## Planning and Land Use Committee Report

For the Meeting of December 10, 2015

**Subject:** Development Permit No. 000439 for 1101 Fort Street

Solar Study - Impact on Zen Building

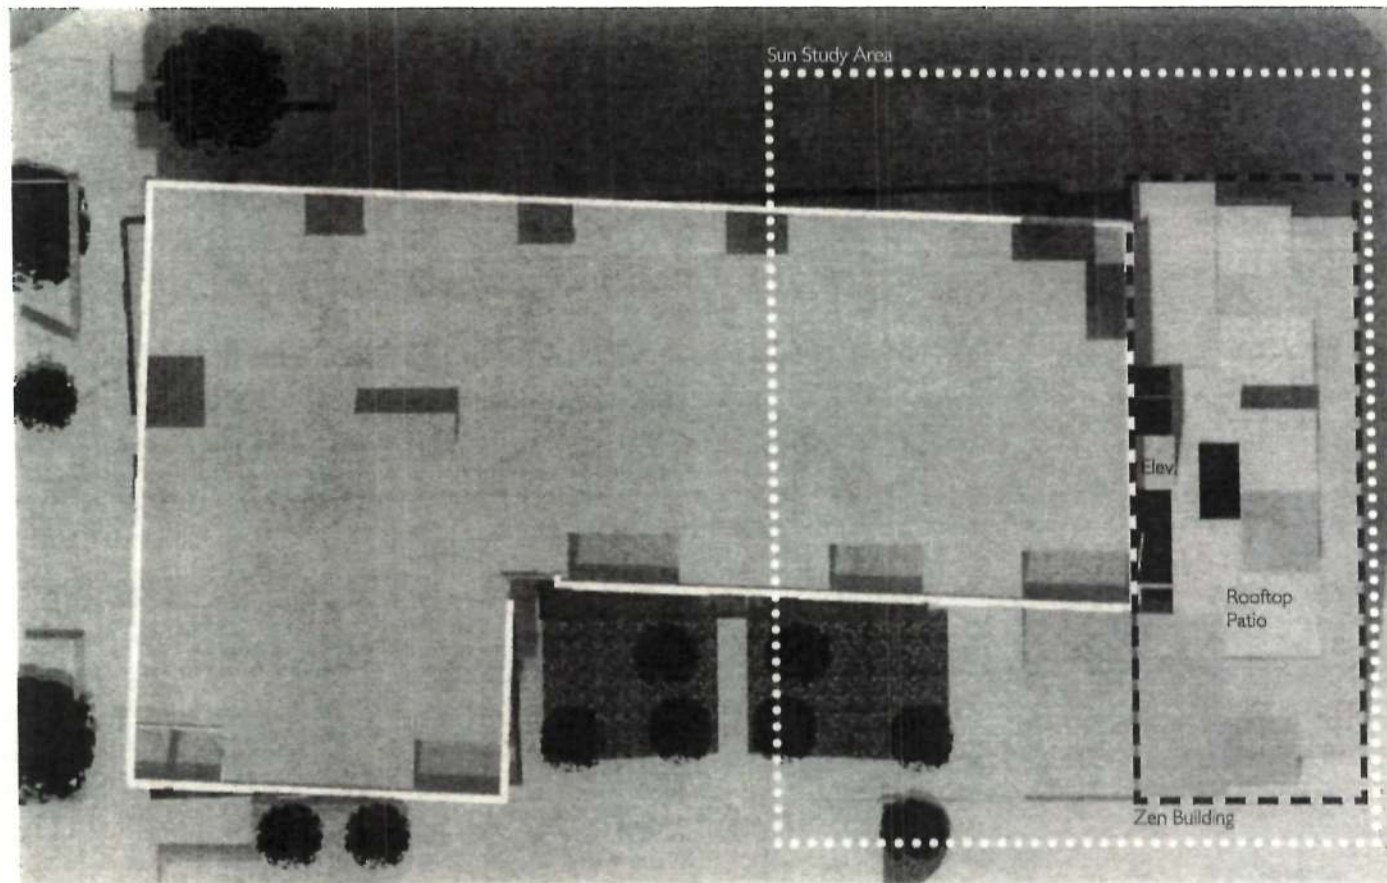
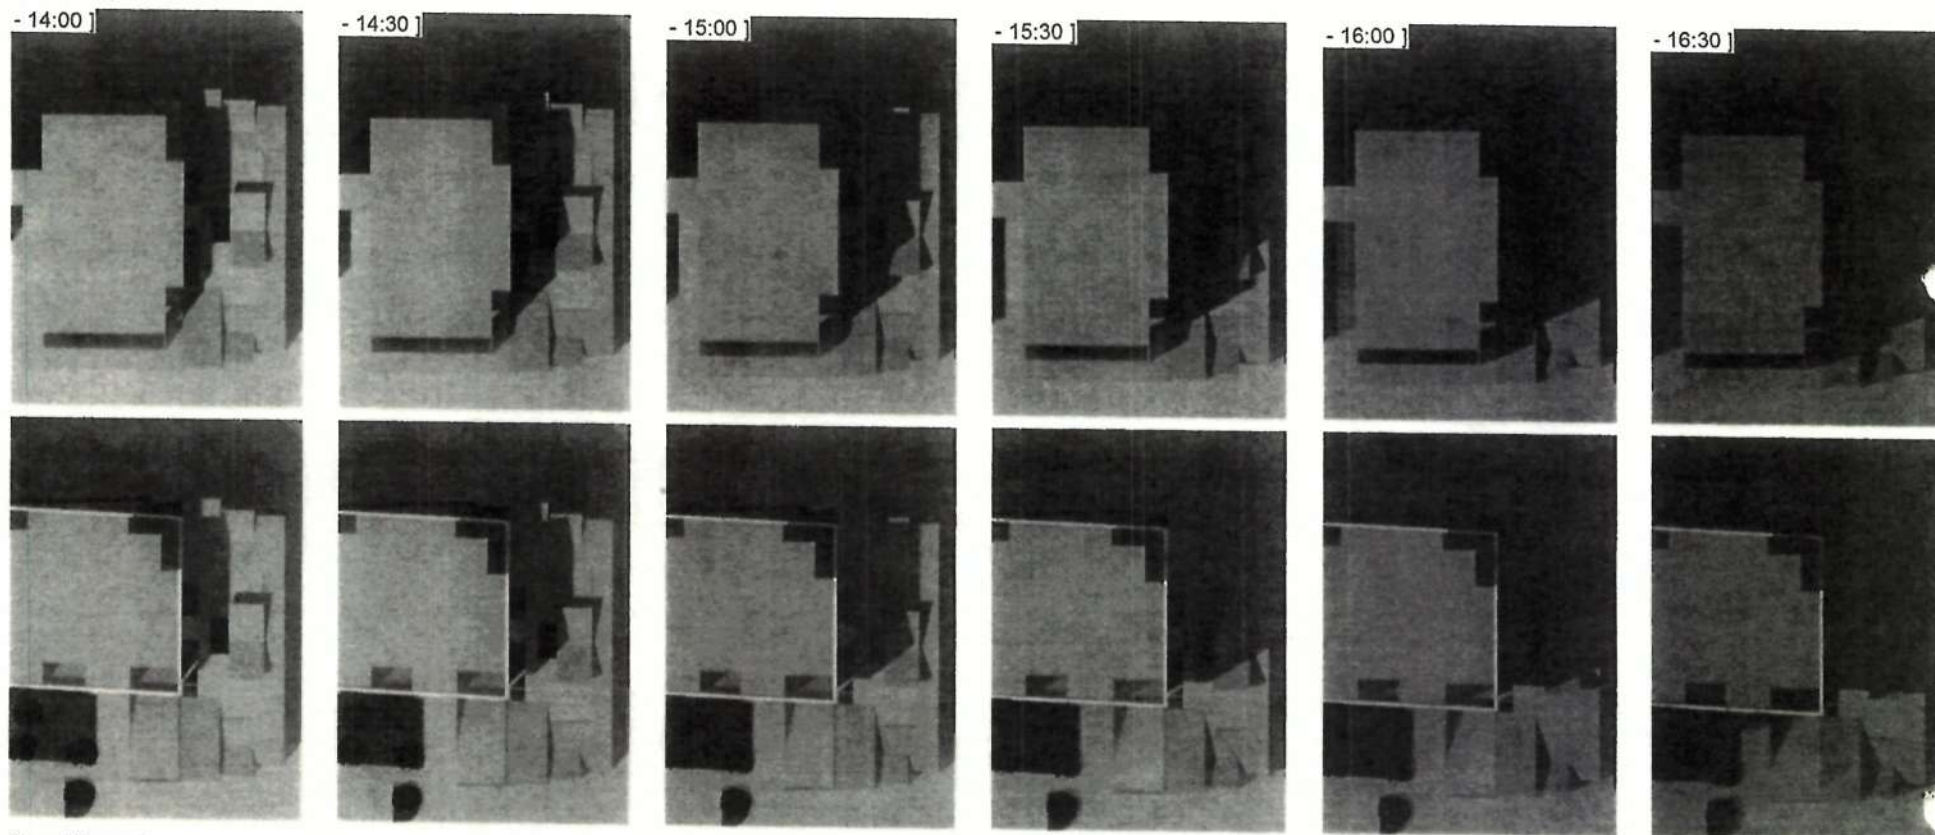
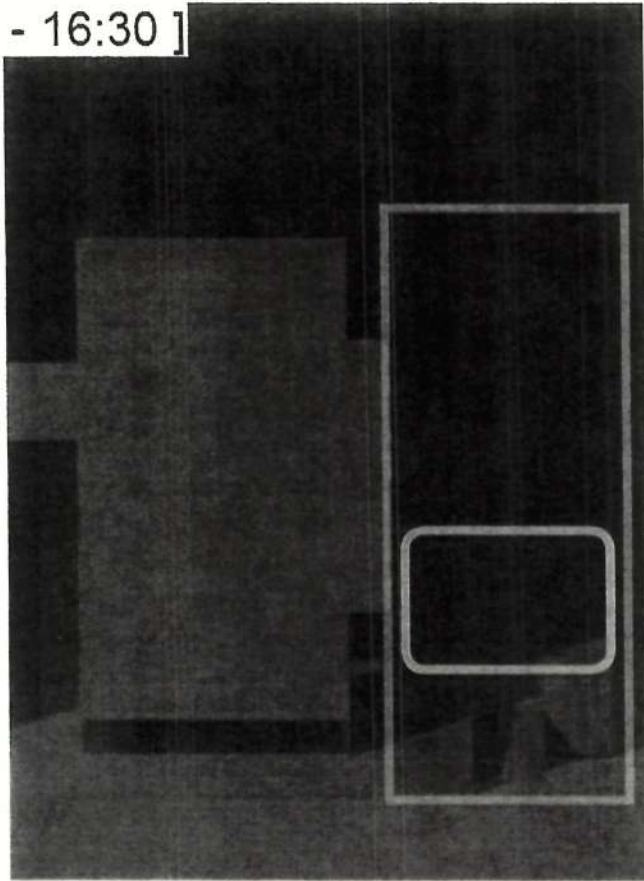
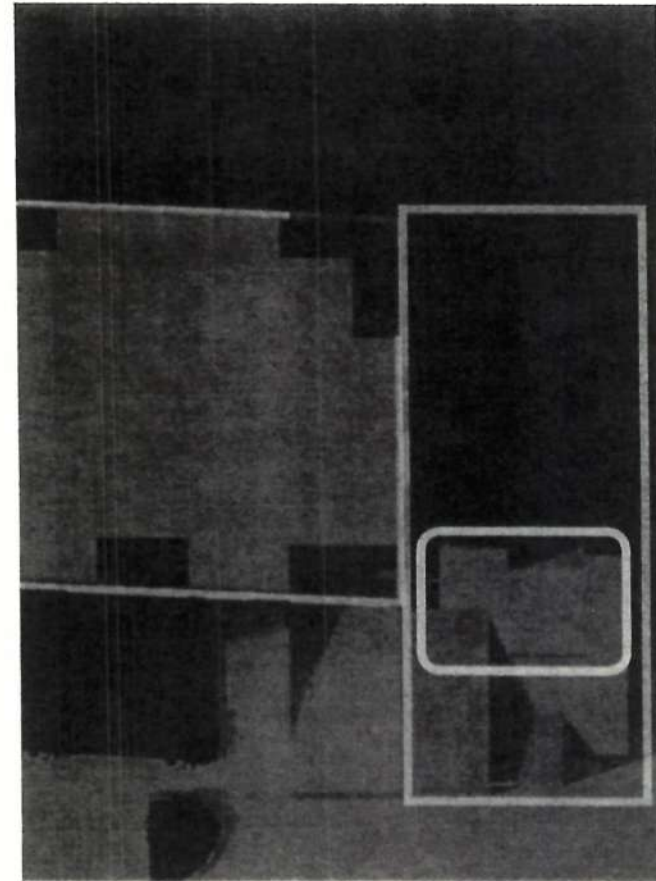
Staff originally raised concerns with the potential impact on the adjacent Zen building at 1121 Fort Street, including the height transition from the adjacent existing four storey building to the proposed six storeys. The applicant has responded by stepping back a portion of the unit fronting Fort Street at the sixth storey and including a deck on the north east part of the building. The provision of this building separation does provide some "breathing room" between the proposed development and the Zen building, but does not address the difference in height. In addition, staff requested further details on the potential impact to the light wells of the adjacent building, although it should be noted that these light wells do not affect habitable space of the adjacent units, only circulation space leading to the unit entrances. Staff welcome ADP's comments on the potential impacts on the adjacent Zen building including any design interventions that could help improve this relationship.

Additionally, based on staff feedback the penthouse level has been pulled away from the Zen building at the NE corner. This achieves a more sympathetic stepped profile along Fort Street, and reduces the building mass when viewed from the Zen. Additional shading studies have been provided that show the clear benefit to the Zen rooftop garden that is the result of this design change from the previously approved scheme. Now the south half of the Zen's rooftop patio remains in the sun for more than 2 hours longer into the evening when calculated at the solar equinoxes.

2 East  
1:100

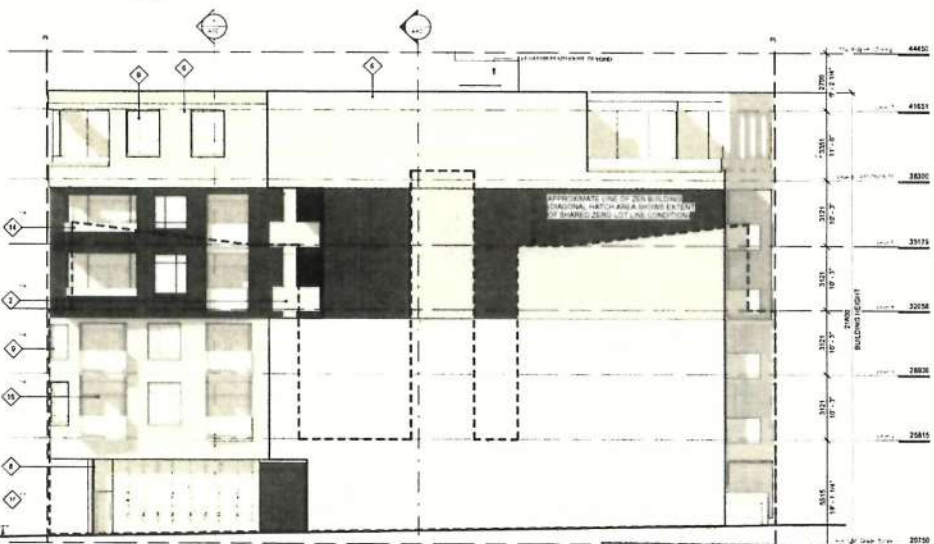
1. **Illustration in greater detail and refinement of the building interface with the Zen project immediately to the east, including relationship of balconies on the north face; relationship with the Zen exterior corridors; and shadowing:**

Refer to drawing A301 which shows the east elevation of the building with the outline of the salient features of the Zen project overlaid. As demonstrated by this drawing, the brick cladding of the upper floors is extended onto the east elevation where it is visible above or outside the Zen building. Portions of the building that are only exposed to the exterior walkways of the Zen will be painted concrete. This drawing also indicates how the 4<sup>th</sup> and 5<sup>th</sup> floors are recessed at the south side and create an overlap where the Zen hallways will retain their view and access to light.

**Landscape Details**

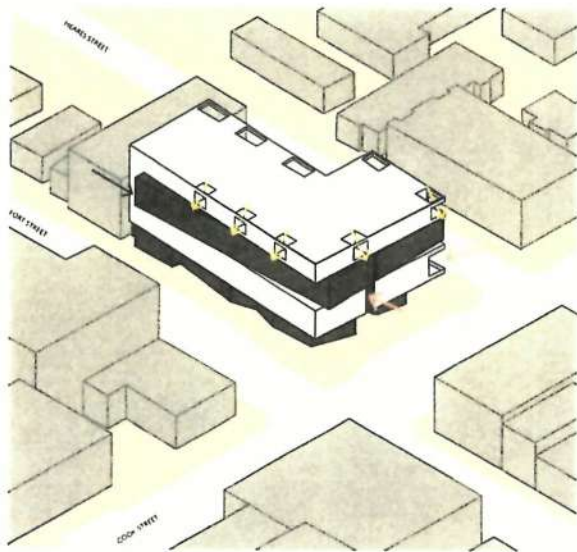
**Additional Landscape Details:** Additional information has been added to Landscape drawings as follows:

1. Bench/Planter Detail, See L 3.01 Detail #1 On-street Seating Wall and Planter.
2. Bench/Planter Detail, See L 3.01 Detail #1 On-street Seating Wall and Planter.

3. Tree grate locations moved to match Site Plan.
4. Bench/Planter Detail, See L 3.01 Detail #1 On-street Seating Wall and Planter.
5. Bench/Planter Detail, See L 3.01 Detail #1 On-street Seating Wall and Planter. Tree layout revised to be outside 7m radius of Stop Sign and one tree removed.

6. Planting Beds removed and replaced with concrete unit paving.
7. Door moved and vine planter shortened.
8. Western planting area specified to have 600-900mm growing medium (depth varies based on underground parking slab), with a total soil volume to be at least 44 cu m. Deck area revised, and garden wall added along sidewalk (see Architect's drawing for grading).

9. Eastern planter specified to have 600-900mm growing medium (depth varies based on underground parking slab), with a total soil volume to be at least 50 cu m. Deck area revised, and garden wall added along sidewalk (see Architect's drawing for grading).

10. Covered bus stop area revised, with longer seating bench.
11. Parking ramp revised widened.
12. Tree species changed from Liriodendron tulipifera to Zelkova serrata.

13. Tree species changed from Aesculus hippocastanum to Zelkova serrata.
14. Tree grate locations moved to match Site Plan.
15. All planting adjusted to be below 600mm.

16. Liriodendron tulipifera removed and Magnolia x 'Daybreak' layout revised.
17. All planting removed from North of parking stalls.
18. Tree species changed from Liriodendron tulipifera to Zelkova serrata.

19. Schematic details for landscape planters and seating wall on public right of way.
20. General: Base plans have been updated so all bicycle and tree grates match site plan locations. Scale of plans are as noted on drawings.
